City of Powder Springs, Georgia
Telecommunications Site Review
New Support Structure

August 7, 2017

RE: City of Powder Springs / PO#18-00067
Municipal Communications / Commodore (Verizon Wireless)

Exhibit A - Proposed Support Structure

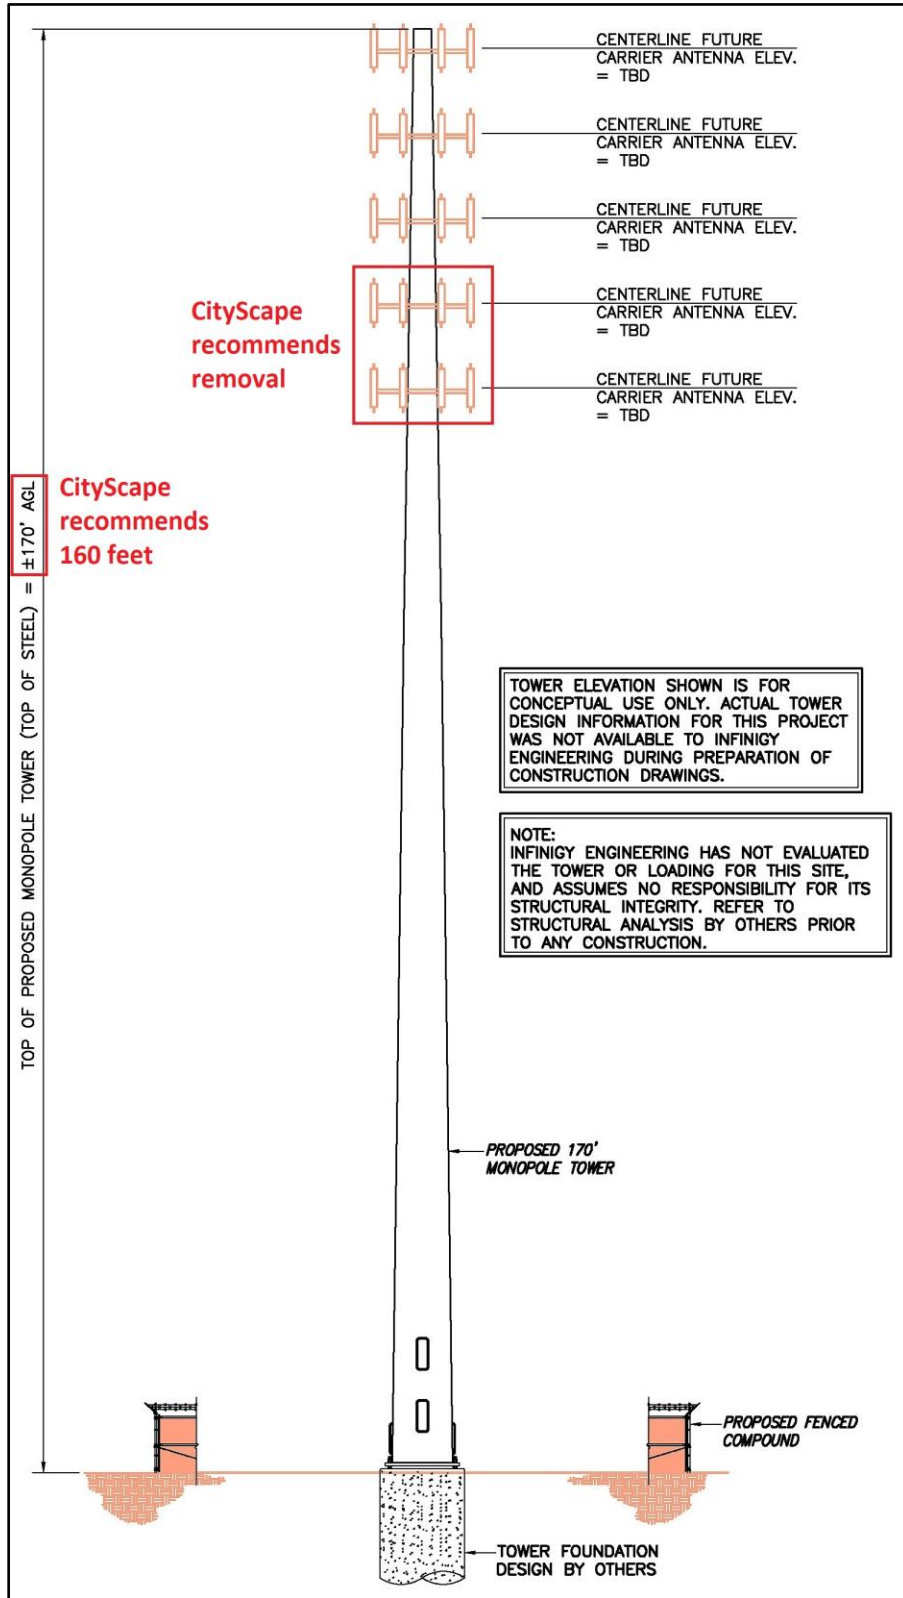
For the wireless communications facility to be justified, its need, location and height must be addressed. The application proposes to construct a new, one hundred seventy (170) foot *monopole* tower, *see Appendix, Exhibit A*. The proposed site is within the Applicant’s search ring.

The Ordinance requires towers over 160 feet in height to accommodate at least 5 tenants. To remain in compliance with this section, a reduction in proposed height by 10 feet (to 160 feet) should suffice the Applicant because a reduction in height of 10 feet in this case should not be significant enough to adversely affect the coverage for Verizon. The reduction in height by 10' would only require the tower be built for three tenants and would lower the visual impact from the residentially zoned properties view sheds by 10 feet.

Finally, if the height of the monopole is reduced to 160 feet then the thickness of the pole can be reduced because it will not be required to have the 5 co-locations and this too will provide less visual impact (less thick and with only three arrays.) The reduction of height, steel thickness and number of co-locations should also reduce foundational costs and require a smaller ground compound, with the need for only 3 providers instead of 5.

With the recommended height of 160 feet in height and the nearest property edge being 32.6 feet to the south, CityScape recommends the Applicant install *breakpoint* technology such that should the tower fail structurally, it will not encroach any adjacent properties. This breakpoint should be no more than 30 feet below the top of the tower (just below the lowest future antenna array).

3. Ground compound fence shall incorporate black vinyl coating on the chain links, as required in the Ordinance.
 4. Monopole should be designed such that structural breakpoint not more than 30 feet below the top; and,

6. At time of permitting, the Applicant shall provide a structural analysis for the proposed monopole with three total arrays of like design, based on ANSI-TIA-222-G (as amended) and sealed by a Georgia Professional Engineer; and,
7. Proposed tower shall be galvanized and not painted any other color without approval of the City. Ground equipment must remain neutral in color (galvanized, gray or white); and,
8. Prior to permitting, the Applicant shall provide approval from SHPO/NEPA offices for the new structure; and,
9. Applicant shall provide notice of compliance with FCC's rules regarding RF exposure and interference to other sources; and,
10. Should surrounding areas be developed in the future, removing the natural camouflage, the Applicant shall install appropriate landscaping on the remaining sides of the compound at such later date.

Exhibit B – Proposed Ground Compound

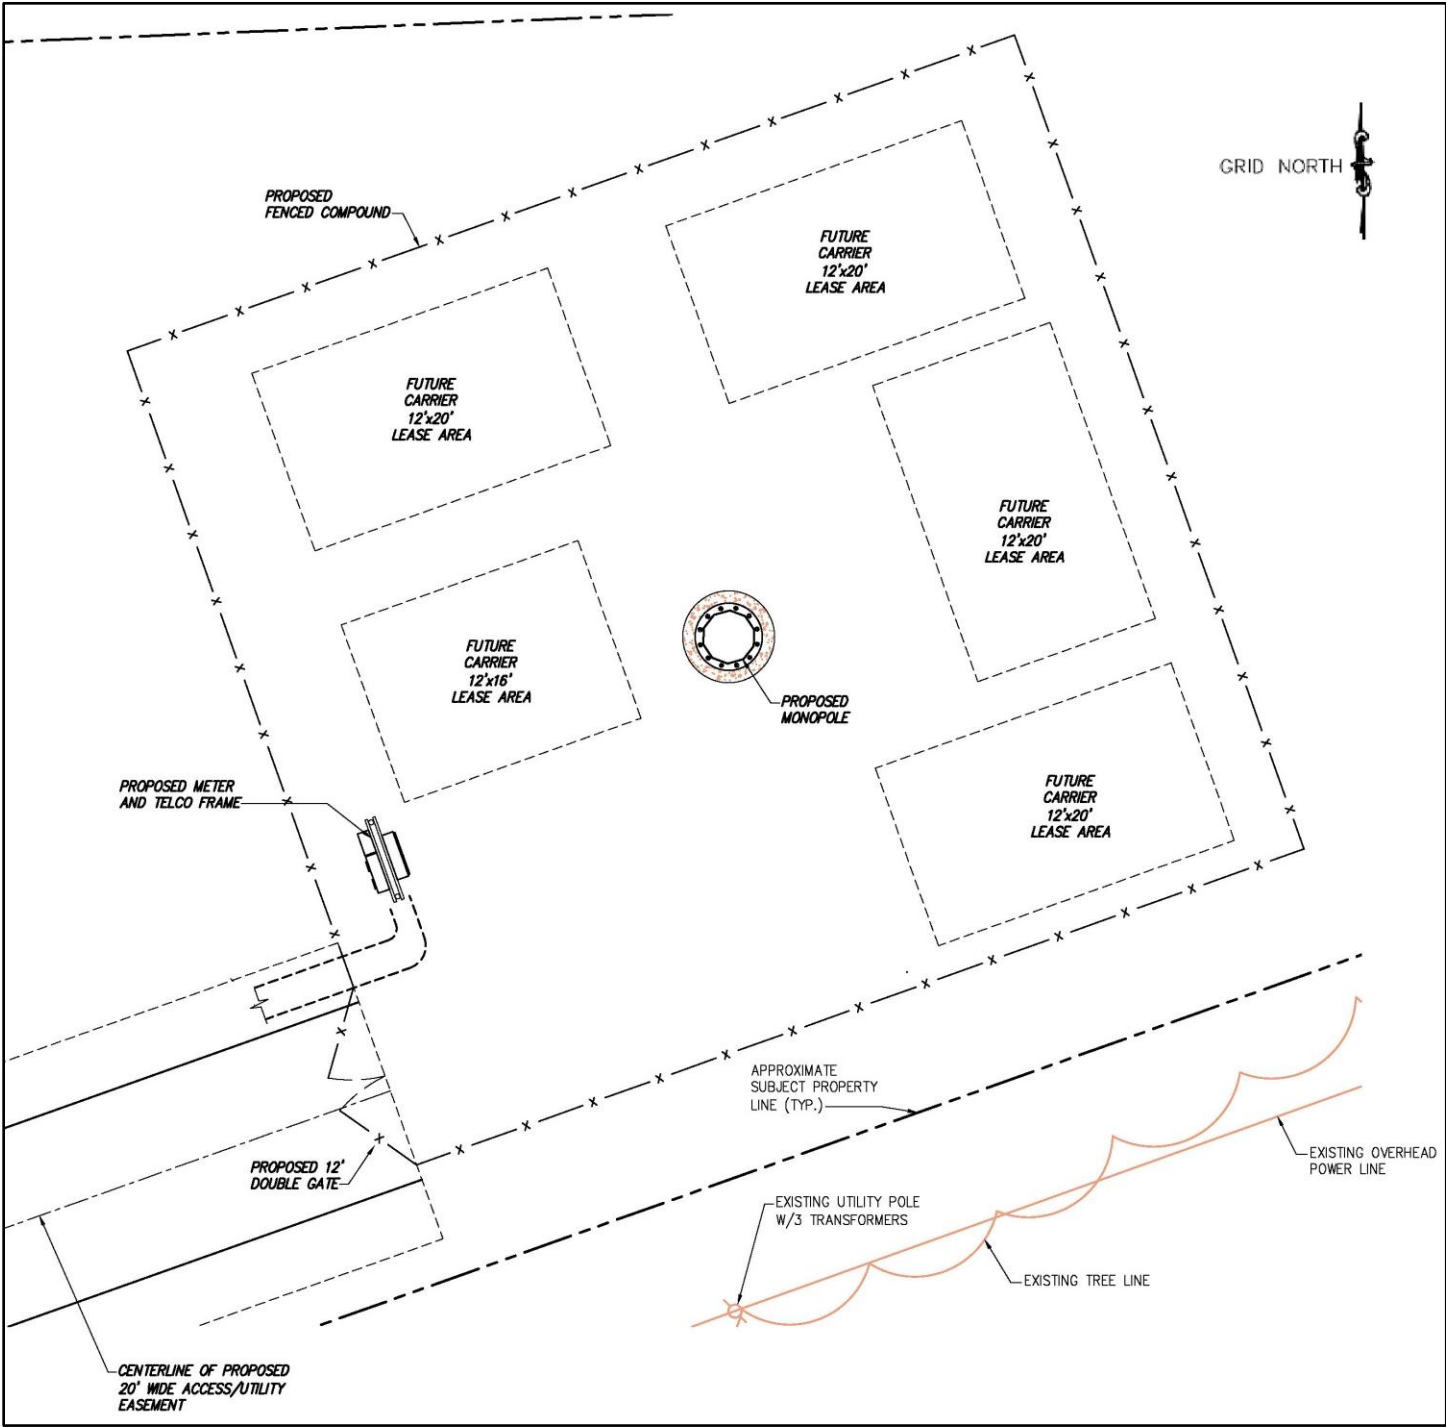
- a. Plat or Survey - Provided by Applicant
- b. Site Plan - Provided by Applicant but the existing building adjacent the southern property lines is shown inaccurately. The existing building is much larger and includes a parking lot and rear access drives.
- c. Elevation view, drawing or simulated photograph - Elevation drawings are provided.
- d. Engineering showing - Provided by Applicant
- e. Structural Integrity – Needs to be provided prior to permitting

The proposed site does not meet the required 300-foot setback with respect to residentially zoned properties. There is residentially zoned property west of the proposed towers across New Macland Road (3216 New Macland Road), which is about 259.9 feet from the proposed tower so the Applicant needs a variance from the 300-foot setback standard. The proposed tower is more than 300 feet from all other surrounding residentially zoned parcels.

The Applicant is requesting a waiver of the landscape requirements because the Applicant intends to use the existing trees surrounding the compound to meet the planting requirements. However, the Applicant does not provide a grading plan or tree preservation plan to identify which trees are to be removed and saved around the compound. The aerial photography provided by the Applicant shows some trees along the southern property line where the access drive is proposed to be built by the Applicant. If these trees are removed then the ground compound will be visible from the roadway. CityScape recommends the Applicant install an “s-curve” in the access drive with either a different entrance at the compound or at New Macland Road to remove the direct visibility of the compound from the road and especially the residences along the road. In addition to the entrance road modification, it may be necessary to install one or more trees to make the road shift effective.

The southern side of the compound may not be visible from the surrounding public roads or residential properties, but is located behind an existing commercial building. It is also only 7.5 feet in width, not the 10-foot minimum required by §4-415(c) of the Ordinance. However,

with the recommended reduction in tower tenants (to three) and likely reduction in needed ground compound size, the Applicant should be able to shift the fencing away from this property by 2.5 feet to avoid the need for a Variance. If adequate plantings do not remain after construction, the Applicant should be required to install appropriate landscaping along this 10-foot southern buffer.

The proposal specifies an adequate 6-foot chain linked fence with barbed wire, but it does not specify the required black vinyl coating the Ordinance states. The Applicant also has the choice of installing a wall.

1. Entrance road shall be modified to add an "s-curve" and appropriate tree plantings on western edge to hide any view of ground compound from New Macland Road; and,

2. Ground compound fencing shall be revised to avoid encroachment within 10 feet of any adjacent properties and a 10-foot landscaping buffer (with appropriate plantings if existing natural buffering is removed) shall be installed on the southern side of the ground compound between the proposed compound and the WCP Equities LLC property; and,
